Licence Number	L7178/1997/11
Licence Holder	Dampier Salt Limited
ACN	008 706 590
File Number:	DER2014/001046-2
Premises	Dampier Salt – Lake MacLeod Blowholes Road CARNARVON WA 6701 Part of Mining Tenements: AML 70/245, L09/10, L09/11, L09/17 and L09/18
Date of Report	3 April 2020
Decision	Licence amendment granted

2. Amendment

Amendment

9. The map depicting emission points defined in Table 2.2.1 and as shown in Schedule 1 is replaced with the figure below.

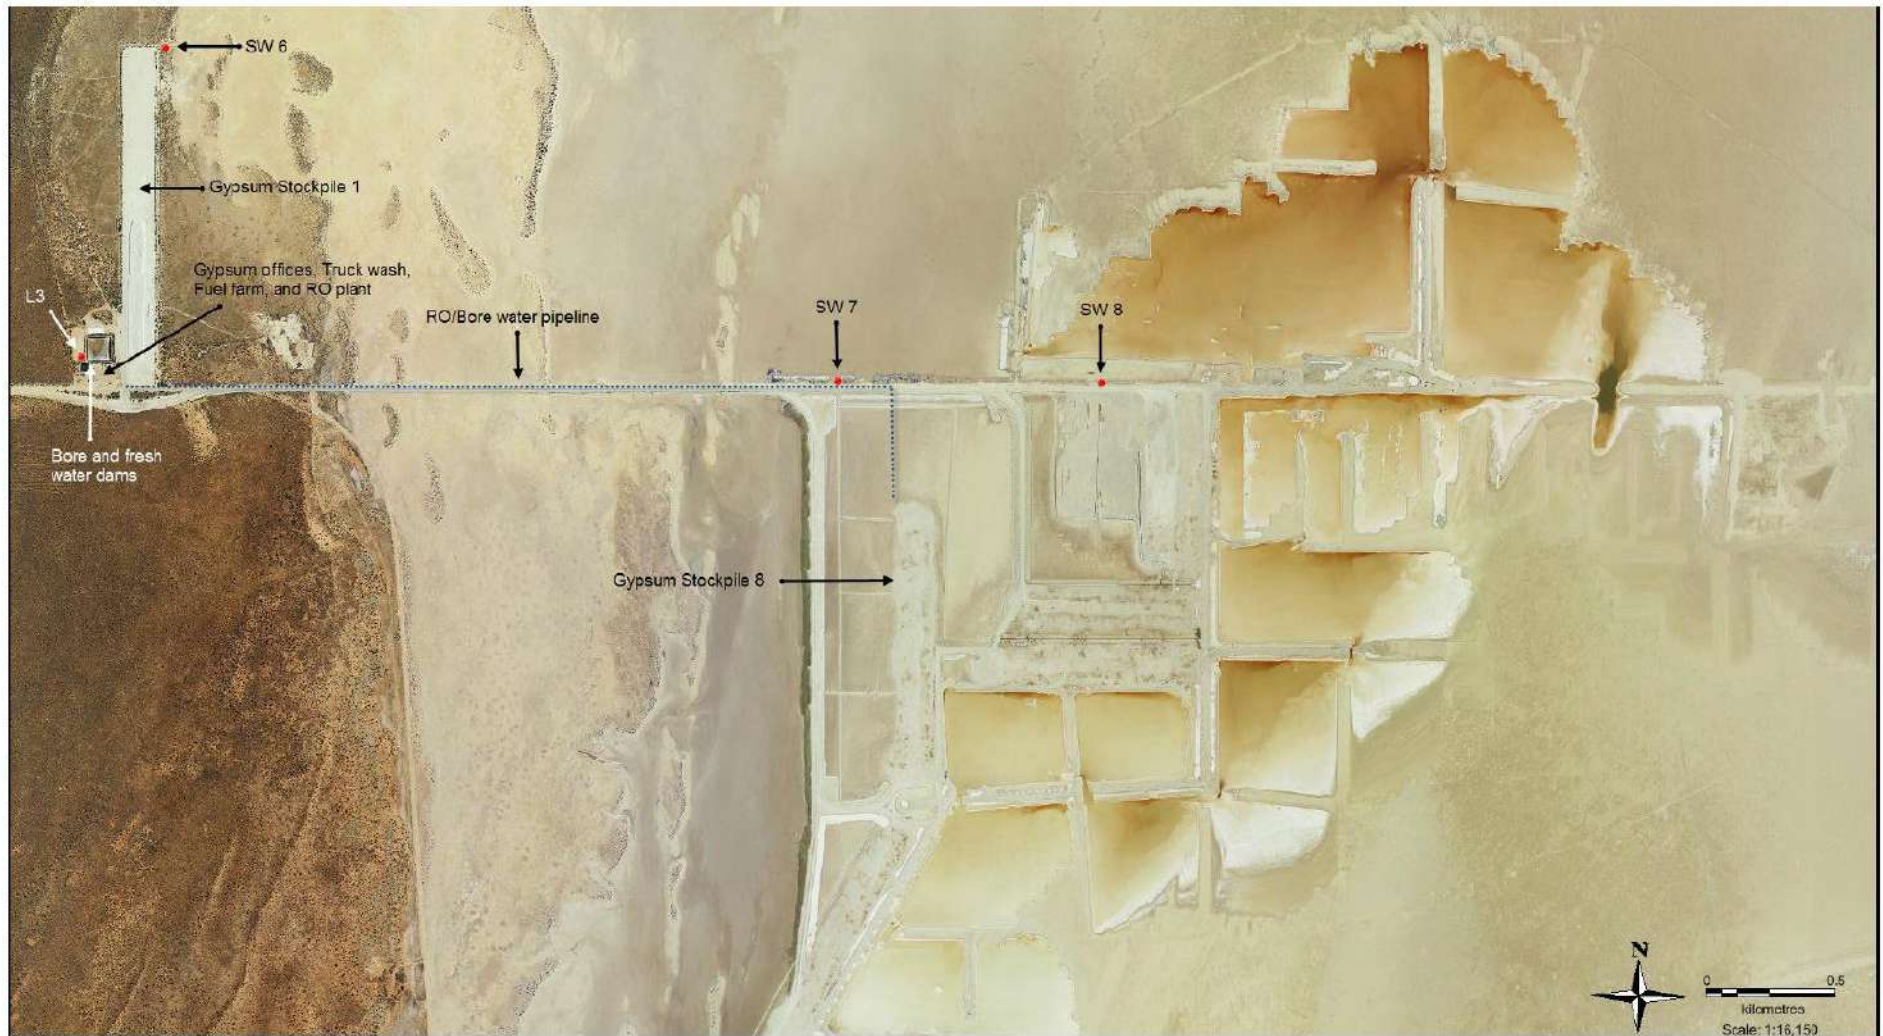
Future discharge point SW8 has been added to the authorised discharge locations to allow for progressive extraction of gypsum further into Lake MacLeod.
